## M E M O R A N D U M

SUBJECT City of Molalla  
Wastewater Facility and Collection System Master Plan

Responses to Oregon Department of Environmental Quality's (DEQ) Wastewater Facility and Collection System Master Plan (WWFCSMP) second review letter are provided in this memorandum. A revised copy of the WWFCSMP is enclosed for your final review.

**FIGURE 1.1  
 NPDES PERMIT SCENARIOS**

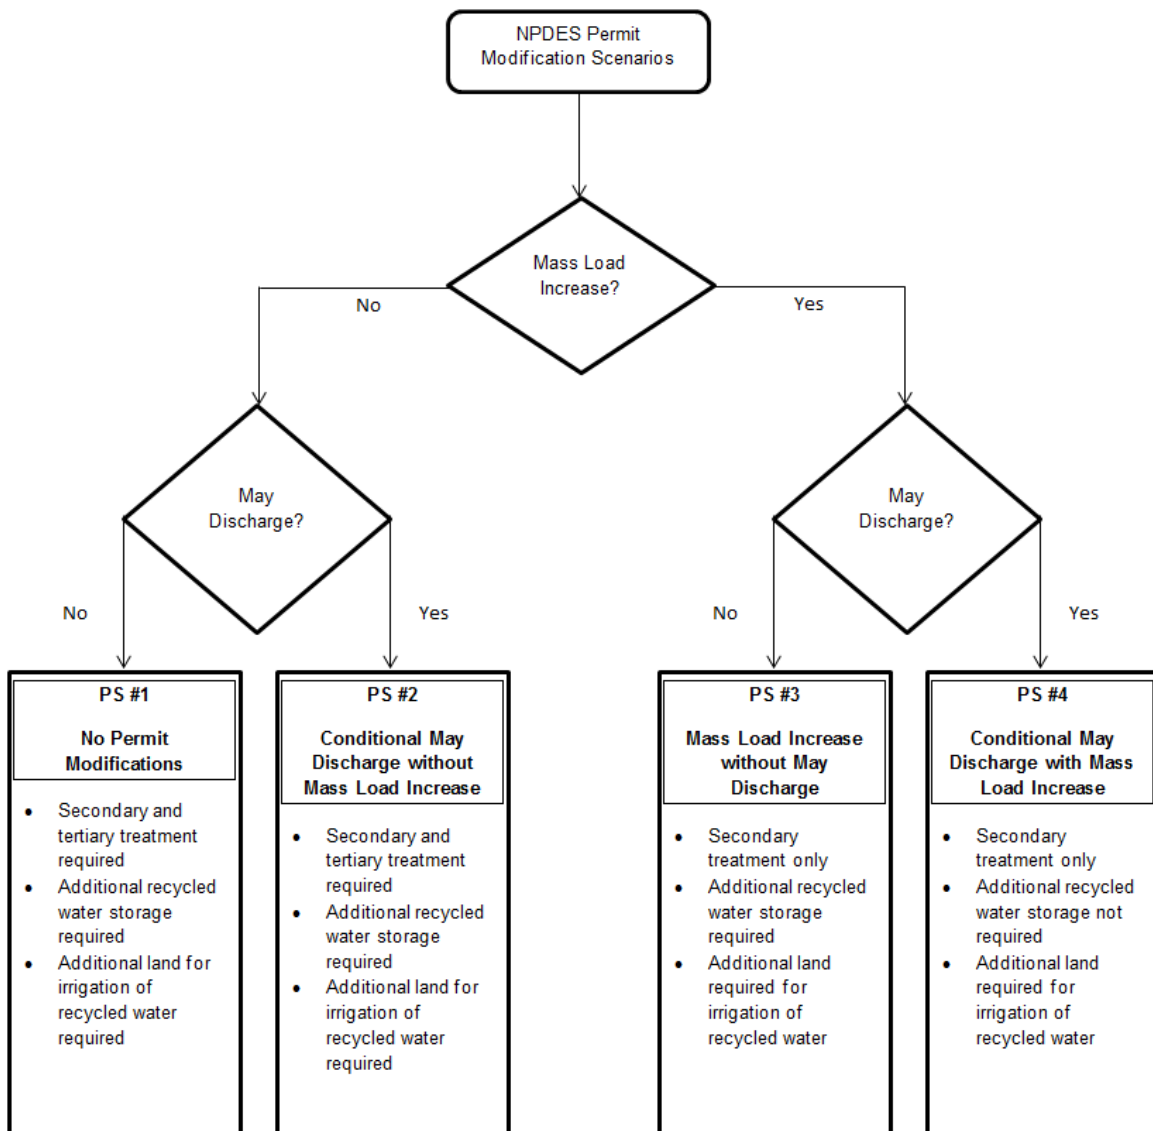
- 1. ES-15 and throughout: Future Potential NPDES Permit: Permit limit negotiation is subject to multiple factors. The facility plan should not count on the "Potential NPDES Permit" limits as the basis for design for a new wastewater treatment plant.***

RESPONSE: The previous draft of the WWFCSMP was developed based on the assumption that the City of Molalla is successful in securing modifications to the NPDES permit that provide an increase in the mass load allocation as well as conditional discharge to the Molalla River during the summer months when river conditions allow. The request to address multiple permit conditions represents a substantial change to the WWFCSMP, and is more comprehensive than adding a single alternative.

The NPDES permit is the primary basis of the WWFCSMP. The basis, relative to the future potential permit, of the previous WWFCSMP draft was based in part on input from DEQ. A WWFCSMP kick-off meeting was held with DEQ and City staff on October 3, 2017. For additional input and concurrence, several meetings with DEQ and stakeholders were conducted during the development of the WWFCSMP. Drafts of each section were circulated to DEQ for comment. This approach is consistent with wastewater planning processes, and was interpreted as such. Drafts of each section were reviewed as they were developed, and consensus was granted. This concern was never previously presented.

Nonetheless, with the main goal of maintaining progress towards permit compliance and avoiding time delays, the WWFCSMP was revised to incorporate additional alternatives, evaluations, and recommendations based on four potential permit conditions. The outcome of the

pending NPDES permit modifications is uncertain and unpredictable, but will certainly have a profound impact on the WWTP, effluent disposal requirements, and costs to construct and operate facilities. Consequently, the revised WWFCSMP includes planning level content to address the four potential future permit conditions. The four possible Permit Scenarios (PS) are illustrated in Figure 1.1, below.
